**Eugene School District 4J
ROOSEVELT MIDDLE SCHOOL**
680 East 24th Avenue
Eugene, OR 97405
CIP No. 410.566.001

ADDENDUM NO. 6

This Addendum forms a part of the Contract Documents and modifies the original Bidding Documents dated February 18, 2015 and subsequent addenda as noted below. Acknowledge receipt of this Addendum in the space provided on the Bid Form. Failure to do so may subject the Bidder to disqualification.

L-101.0

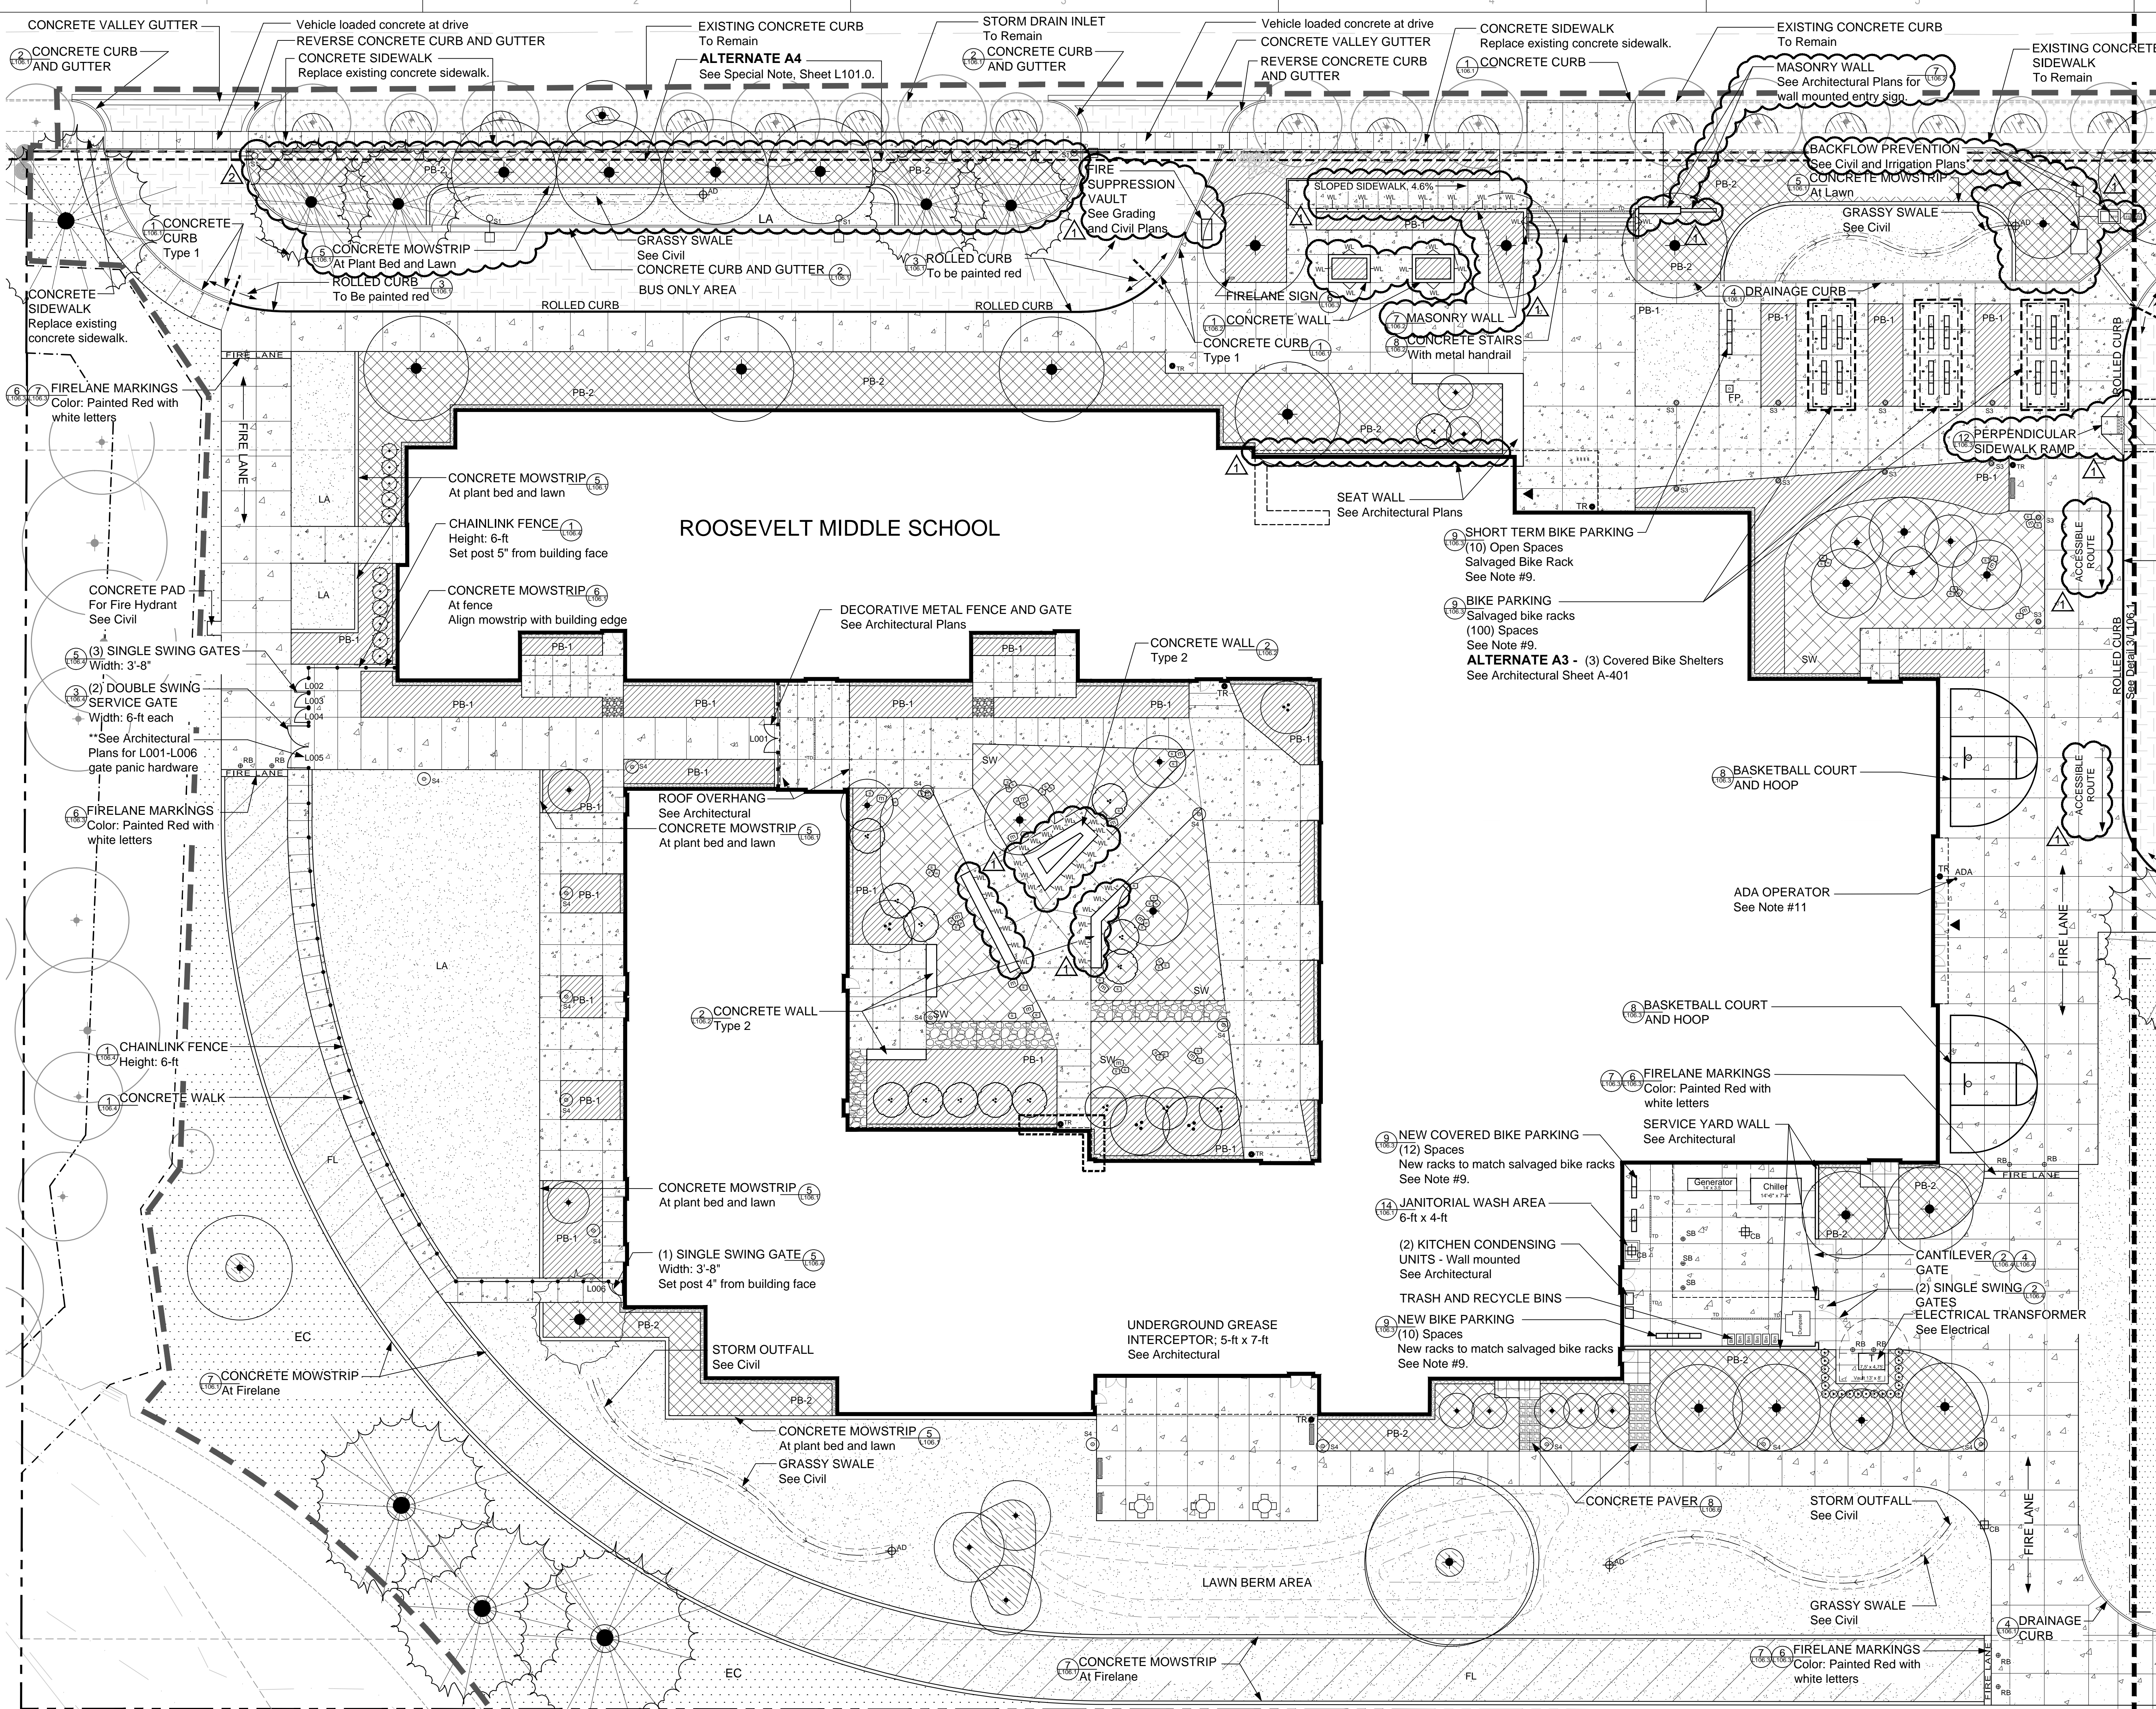
- A. Replace Sheet with revised Sheet L101.0: Adjust grassy swale and area drain north of bus drop off area. Add concrete mowstrip at grassy swale north of bus drop off area. Add trees along north edge of parking lot per the City of Eugene Land Use Review Comments.

L-101.1

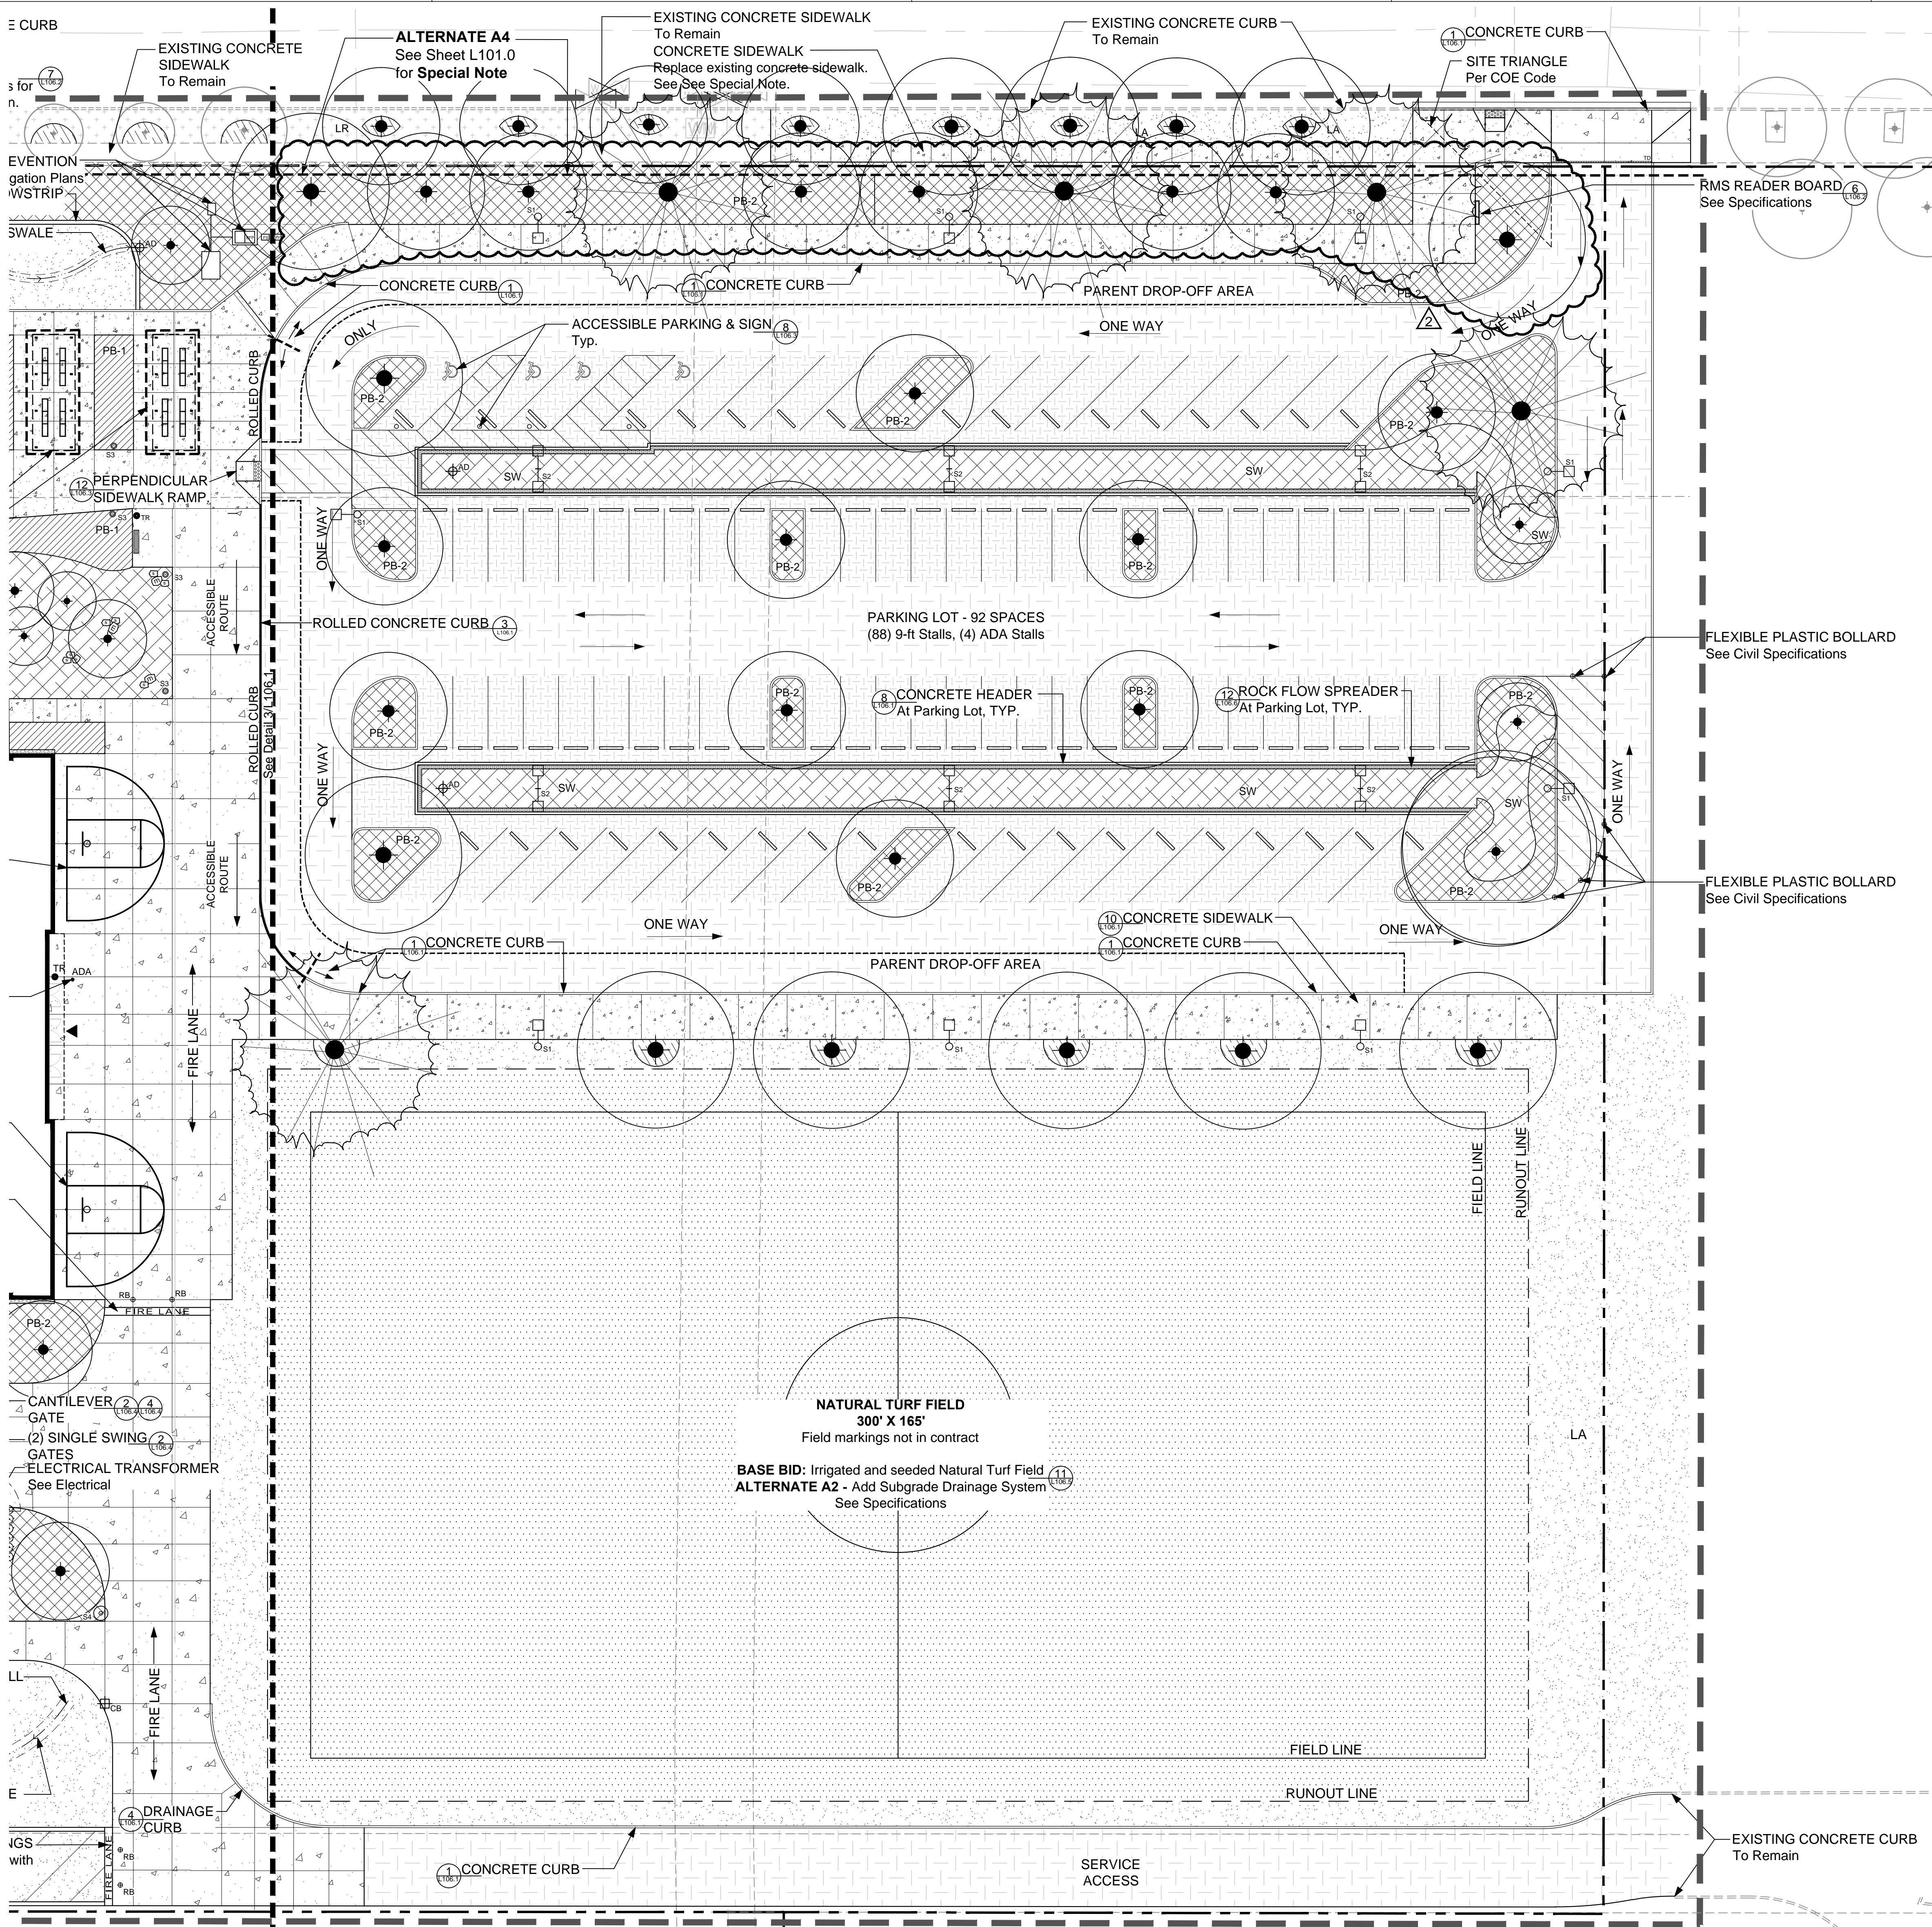
- A. Replace Sheet with revised Sheet L101.1: Adjust grassy swale and area drain north of bus drop off area. Add concrete mowstrip at grassy swale north of bus drop off area. Change Eco Lawn legend item to be Non-irrigated.

L-101.2

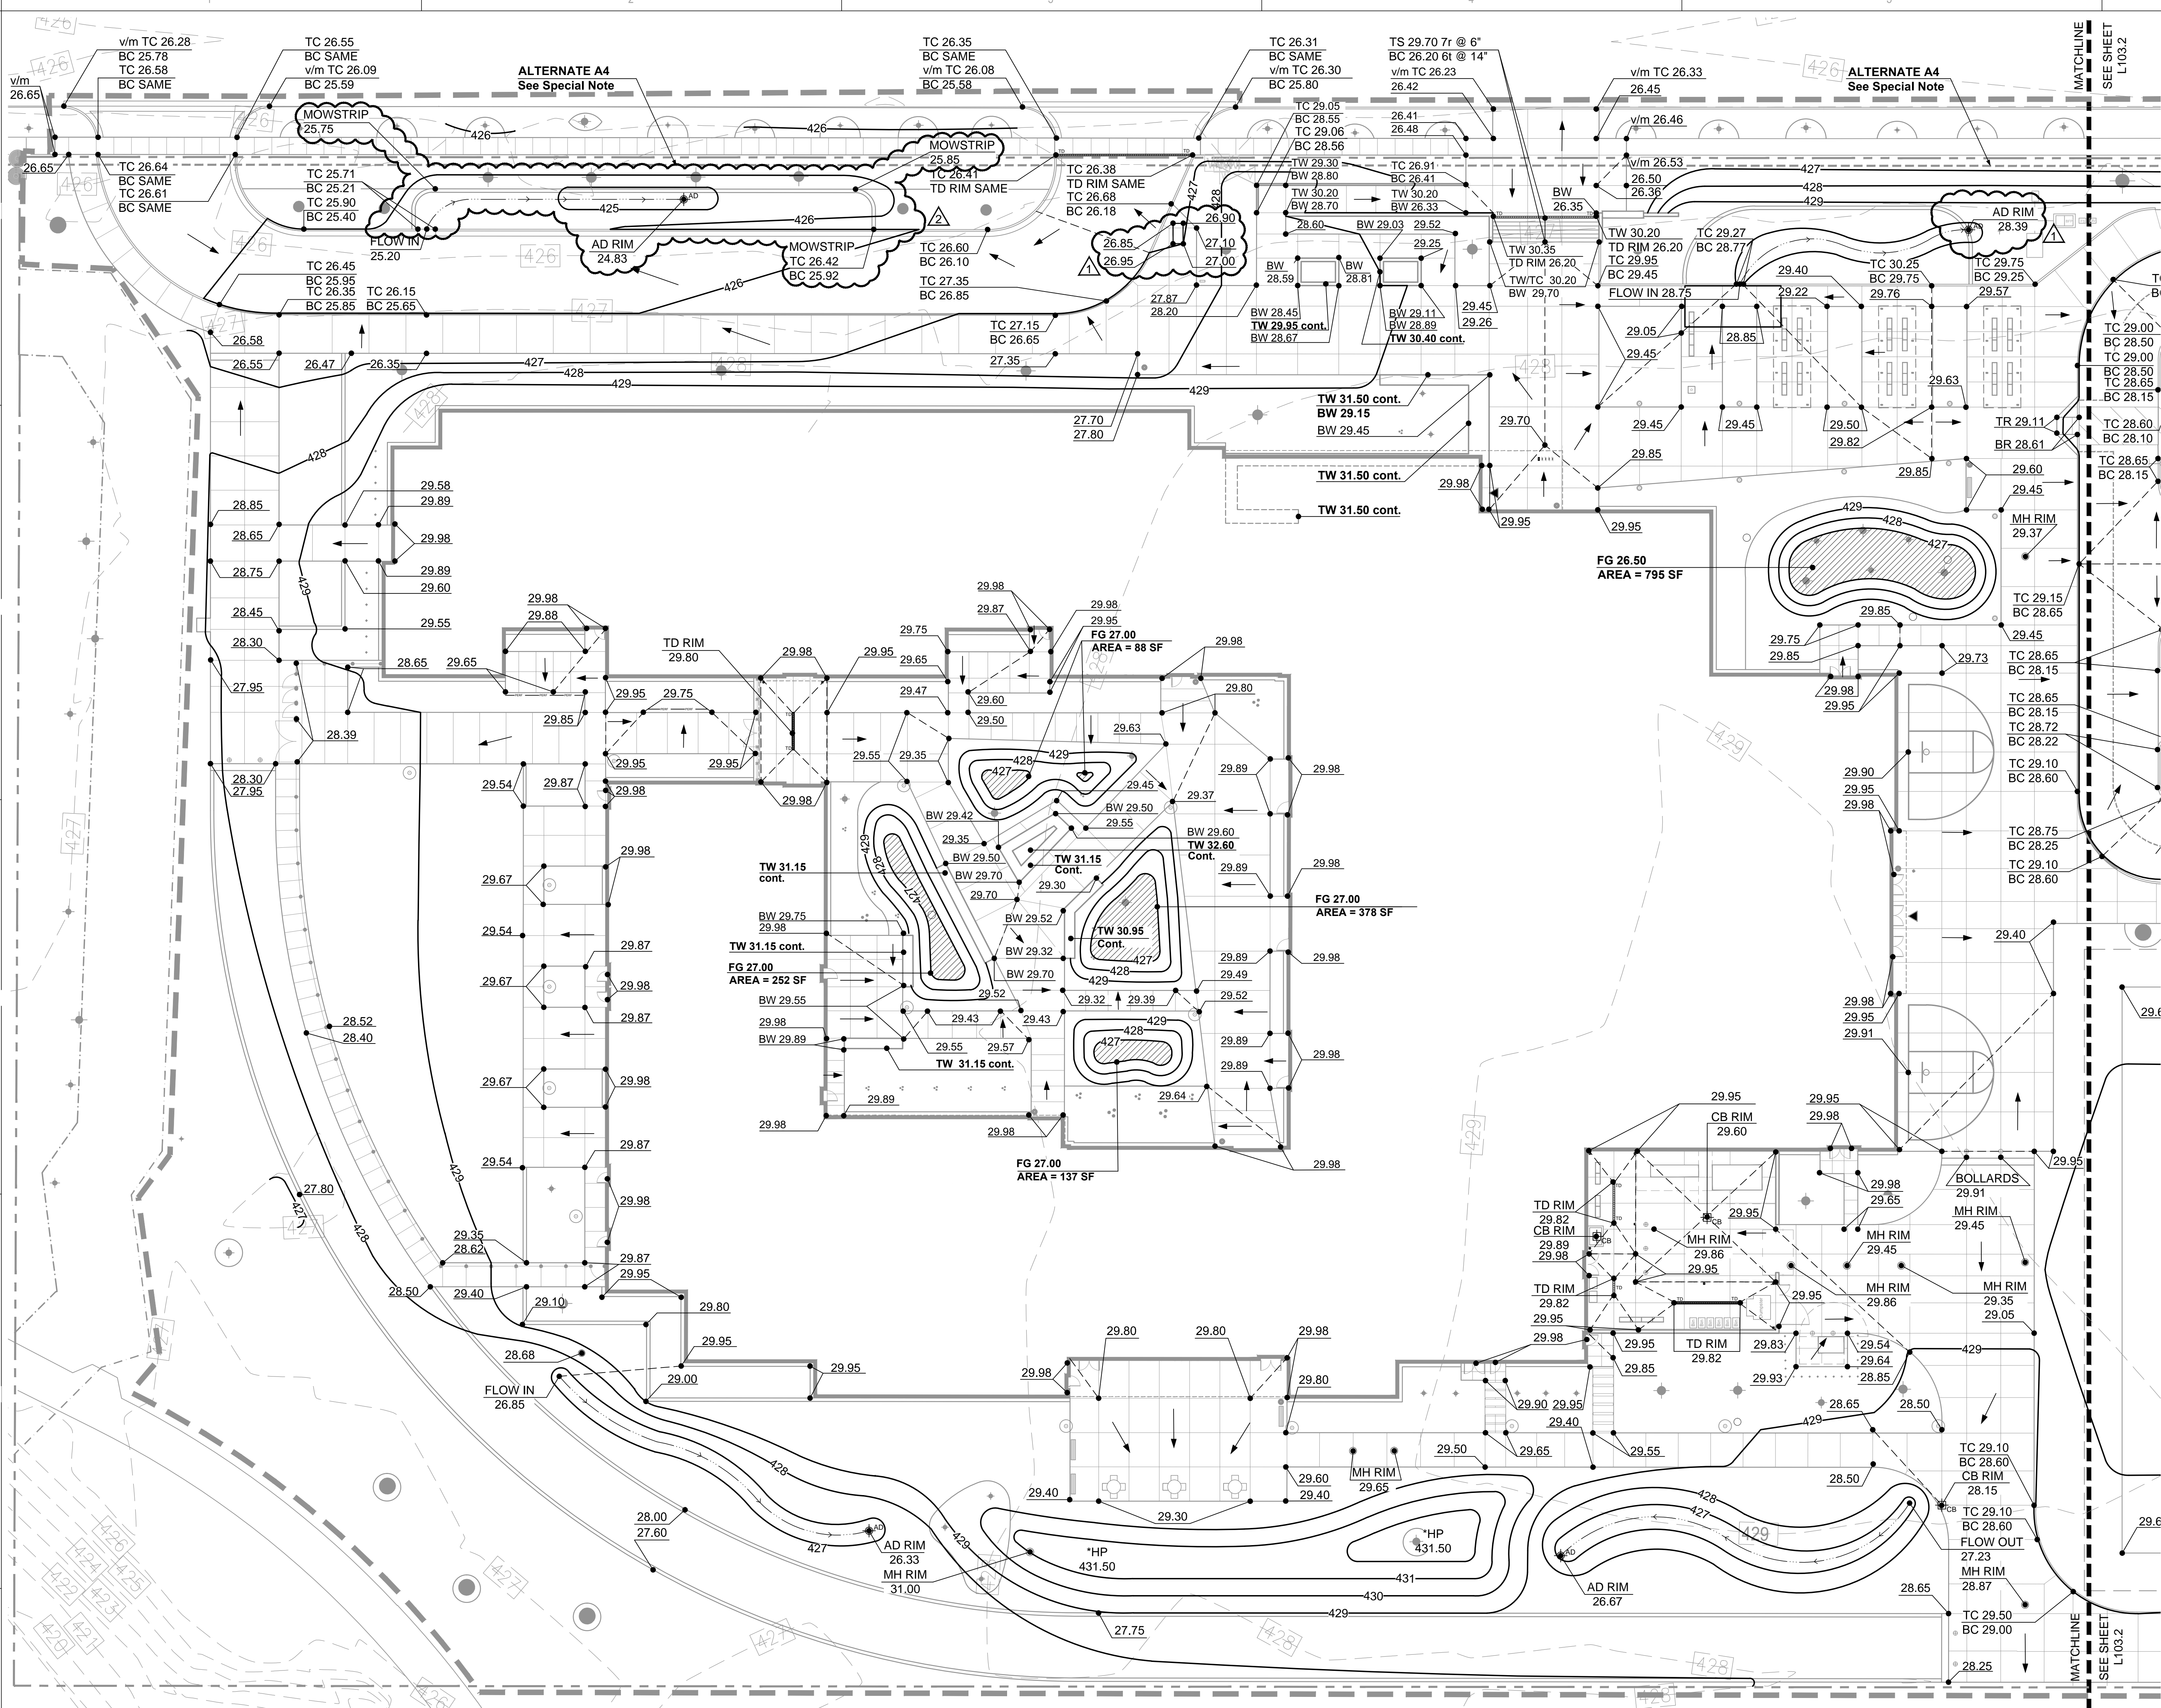
- A. Replace Sheet with revised Sheet L101.2: Change Eco Lawn legend item to be Non-irrigated. Add trees along north edge of parking lot per the City of Eugene Land Use Review Comments.
